# **Report on Consultation - Alignment and Site Selection**

## **Red John Pumped Storage Scheme 275kV**

### **Connection**

**REF: LT325**

**Figure 3**  
**Proposed Alignment**

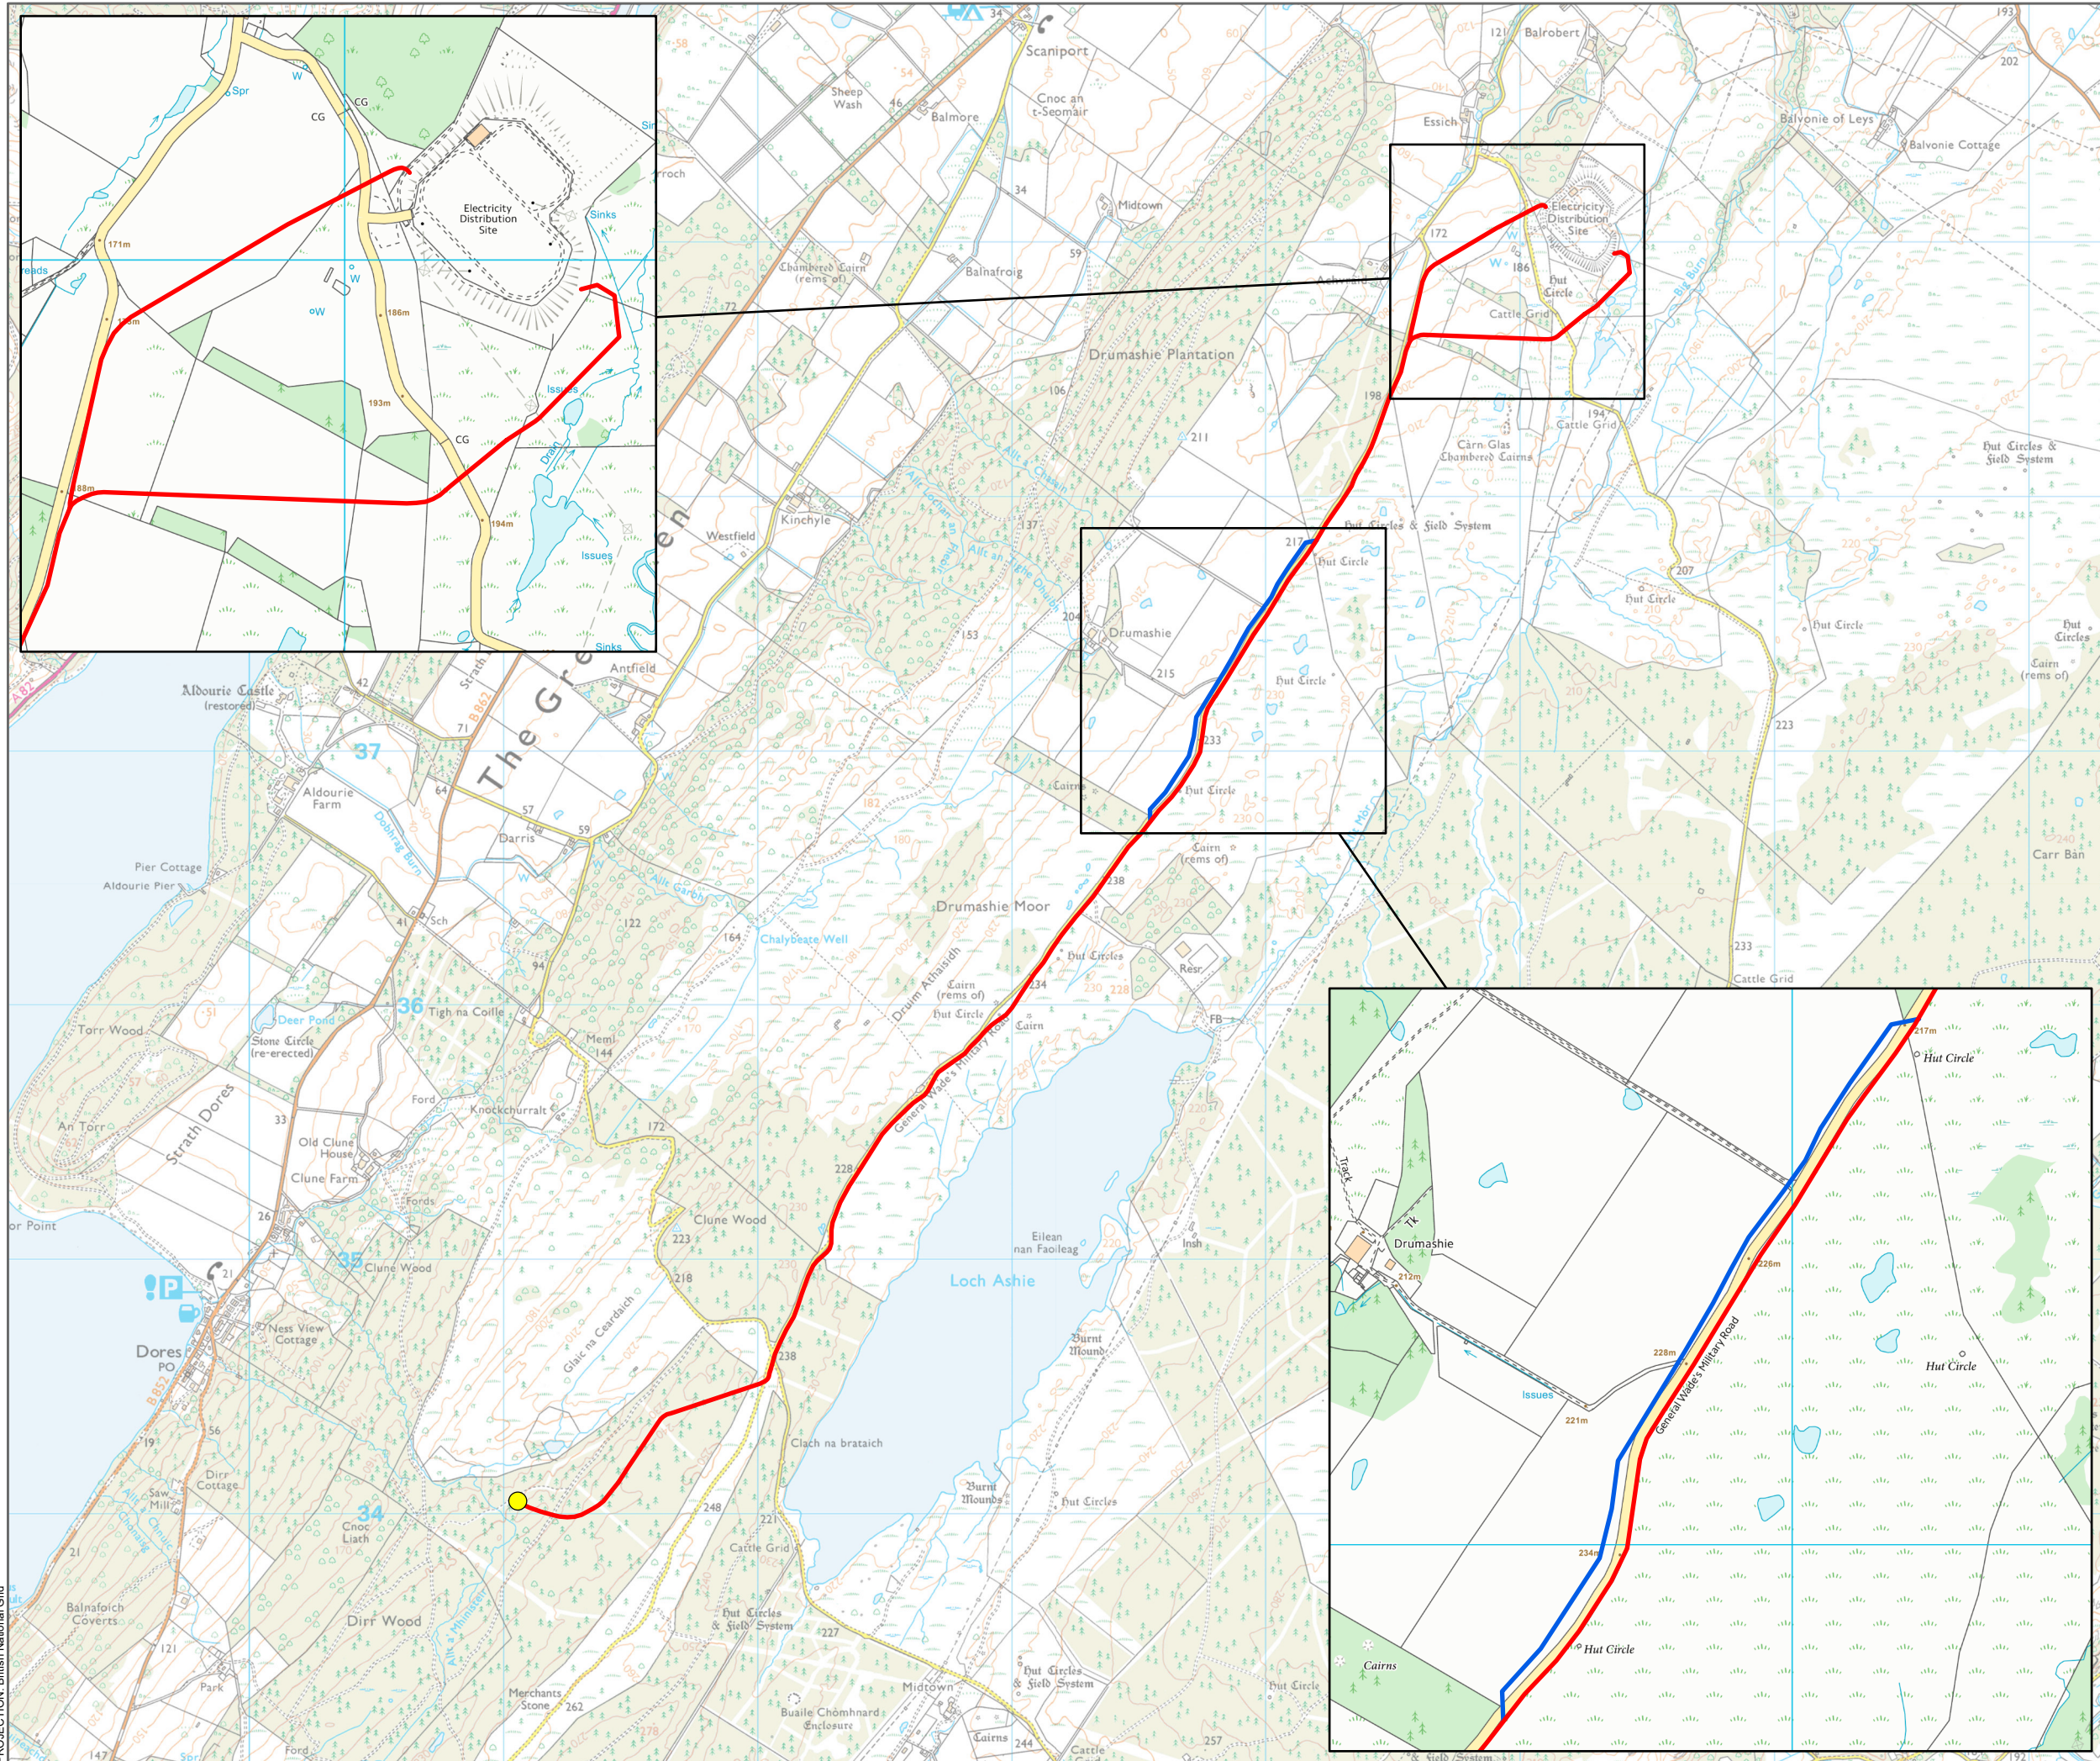
Topic	Comment received	SSEN Transmission Response
Planning	It was noted that a planning application for a battery storage site south of the existing substation had been submitted. The current preferred alignment would pass through this site area.	SSEN Transmission have amended the proposed alignment to avoid the battery storage site.

Variation 1 deviates from the preferred alignment, heading north-east from General Wade's Military Road between two areas of woodland. It then passes north over Essich Road and continues on this alignment to the east of Knocknaegal Substation (see **Appendix A, Figure 3**).

It was proposed in response to a battery storage site planning application between General Wade's Military Road and Essich Road. Variation 1 offers potential benefits in terms of reducing impacts to breeding bird habitat, woodland and non-designated heritage assets however there are two prehistoric hut circles, which would require excavation by watching brief.

The Proposed Alignment is shown in **Appendix A, Figure 3**. The Proposed Alignment follows Variation 1 described above. It is considered that the Proposed Alignment has responded to comments and concerns raised during the consultation process.
